# PARTS & SERVICE NEWS

REF NO.	AT04392
DATE	December 24, 2004

**SUBJECT:** MODIFICATION PROCEDURE TO REPAIR BROKEN MOUNTING BOLTS FOR THE AIR COMPRESSOR OF THE AIR CONDITIONING SYSTEM

Fig. 1

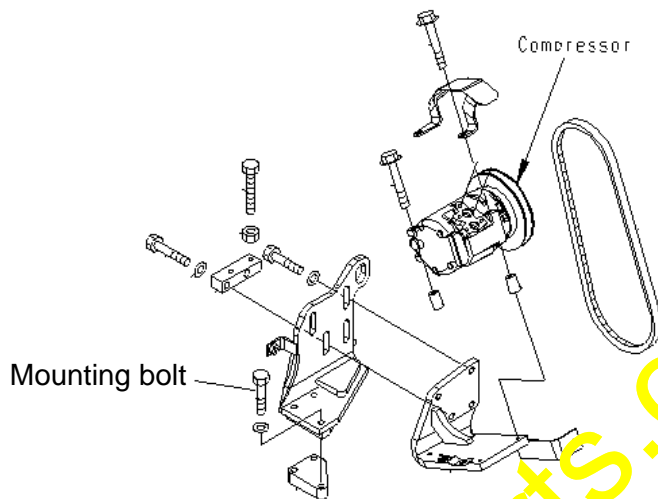
The mounting bolts for the air compressor of the air conditioning system become broken owing to resonance of the air compressor bracket to the engine vibration.

- 1) The air compressor bracket for the air conditioning system has been strengthened to prevent occurrence of resonance to the engine vibration.

Fig. 2

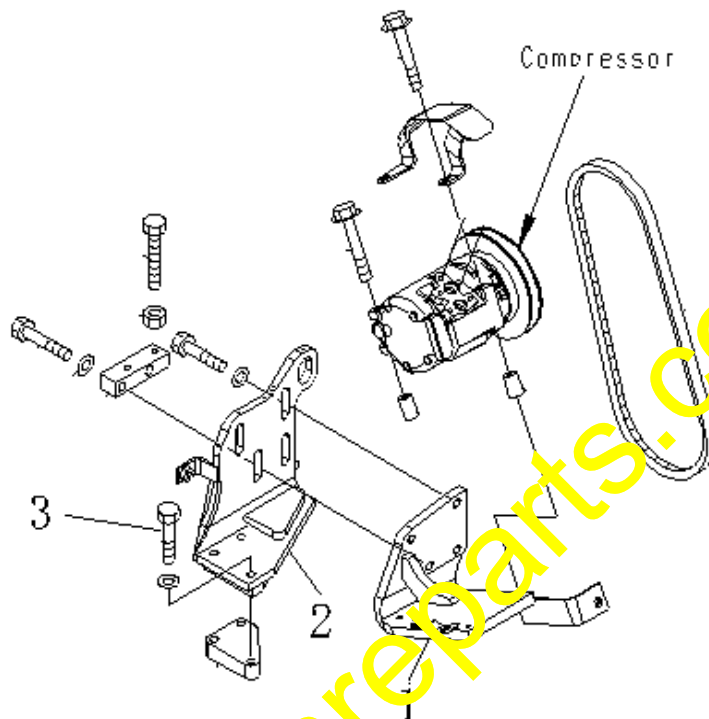
Replace the parts indicated in Fig. 2 with the improved parts.

Part name	Parts before the modification	Improve parts
1. BRACKET	416-S62-3183 →	416-S62-3184
2. BRACKET	416-S62-3176 →	416-S62-3177
3. BOLT	01010-81060 →	01010-81065 (3 pcs.)
